Union Knitting and Dyeing Ltd

42&44 Boro Rangamatia Zirabo Savar, Dhaka

01st October 2018

Observations

C1 (Column Schedule)

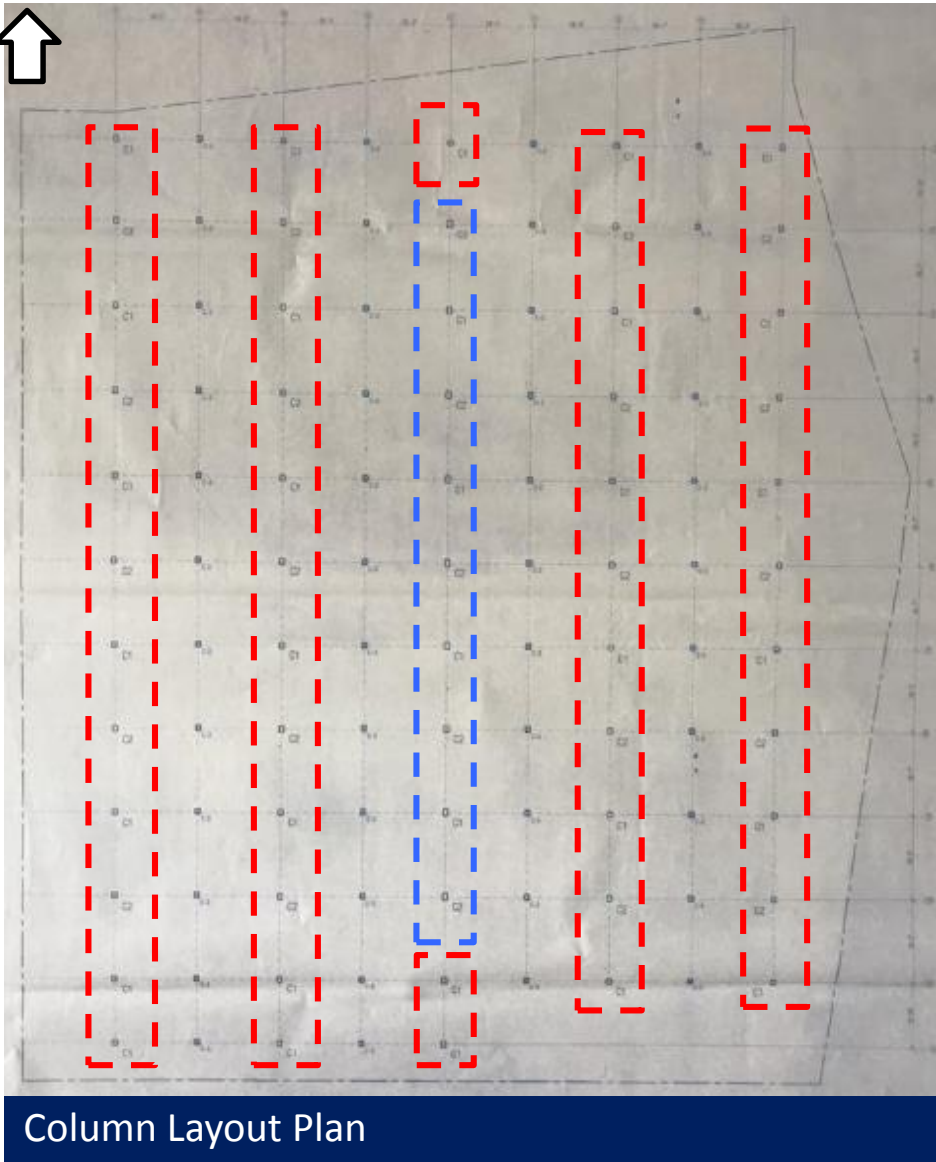
Column layout of onsite condition did not match with provided drawing. In the blue marked location and red marked location, 10inch x 15inch column, and 10inch x 12inch was found respectively. Whereas in the provided column layout, C1 and C2 type column was shown as the alternate arrangement in the North-South direction.

Item No.	Observation	Recommended Action Plan	Recommended Timeline
1	(Production shed) Discrepancy between as-built drawings and on site condition	Factory engineer to survey the whole building and produce as-built documentation which reflects the as constructed condition.	6-weeks
2	(Production shed) Lateral stability is required to check	Factory is required to check stability against lateral and vertical loads.	6-weeks
3	(Production shed) Lateral stability is required to check	Carry out remedial action as per engineering assessment where required.	6-months
4	(Production shed) Capacity check of roof slab and steel frame supporting water tanks is required	Factory engineer to review design, loads and related elements including roof slabs in area identified above to confirm capacity of the tanks.	6-weeks
5	(Production shed) Capacity check of roof slab and steel frame supporting water tanks is required	Factory is required to improve the drainage system for preventing the water clogging on slab.	6-weeks

Typical frame (From Drawing)

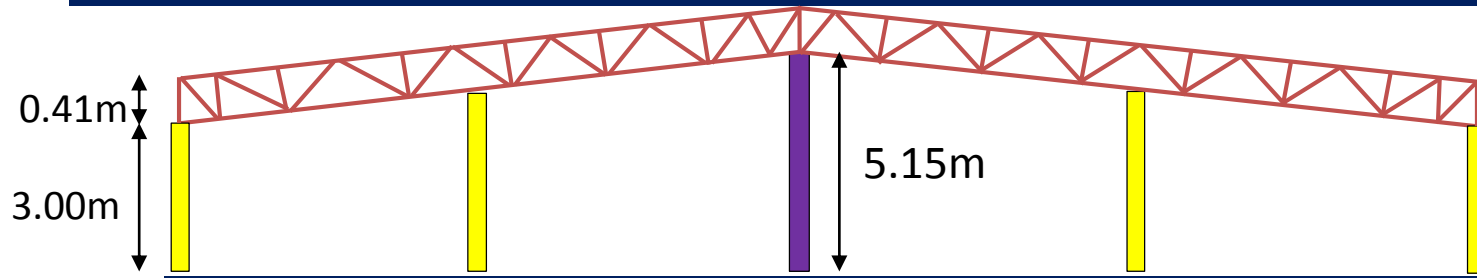
In the provided structural drawing rafter was mentioned as roof framing system whereas truss frame was found on site. Factory is required to produce as –built drawing which reflect the onsite condition.

2000 litre water tank on steel frame over men toilet roof top

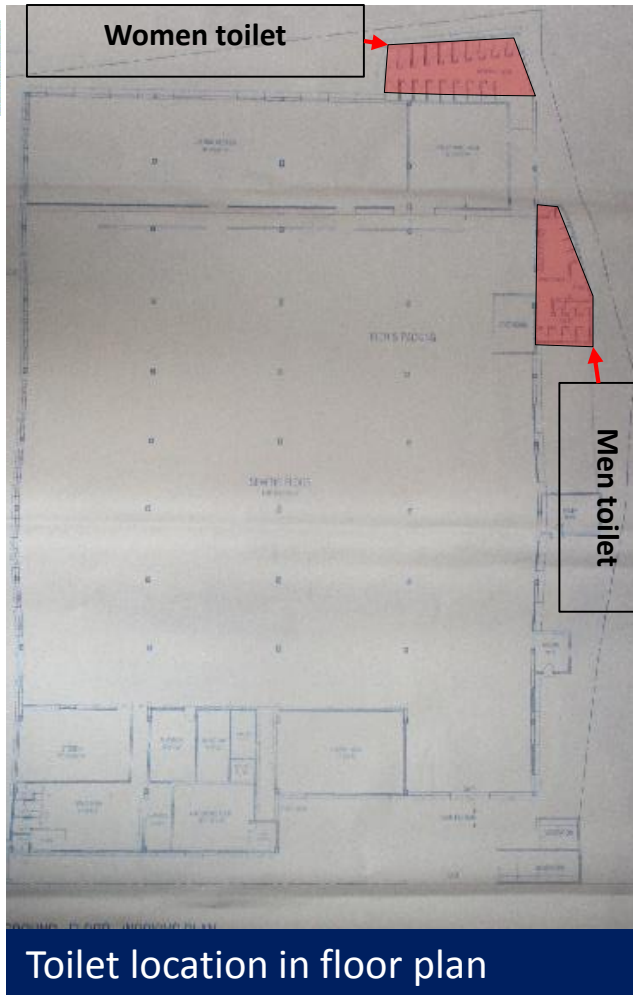
Concerns on the roof slab and steel frame supporting 2000 Liter water tanks. A capacity check of these slabs and all related elements need to be carried out. In addition, improve the drainage system for preventing the water clogging on slab.

6	(Production shed) Capacity check of roof slab and steel frame supporting water tanks is required	Carry out remedial action as per engineering assessment where required.	6-months
